# Access Compliance Report

## Public Rights-of-Way

### (Curb Ramps)

Intersection ID: 10039540	Main Street: THERMAL_RD	Cross Street: N/A	Location: NW
ADA ID: 09E5E64EFF31	Ramp Type: Directional1	Initial Pass/Fail: Fail	Overall Compliance: No
		Severity Score: 22.5

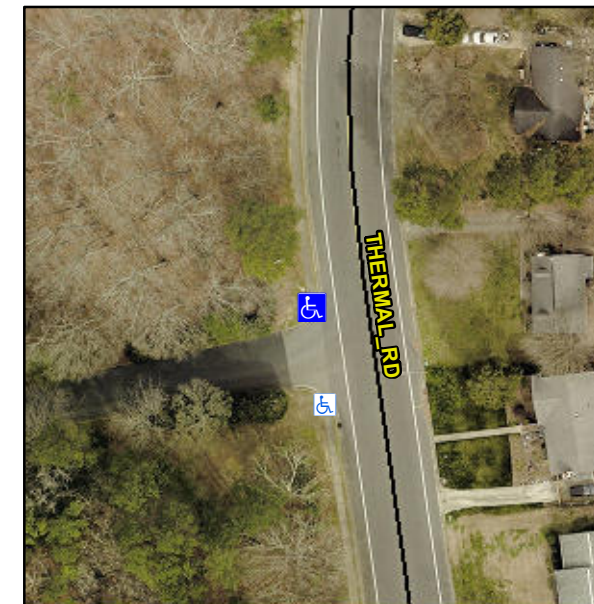
**ASP LIP 1.5", CURB LIP 1.0"**

**R304.5.1, R304.2.2**

**Remove & Replace Entire Ramp.**
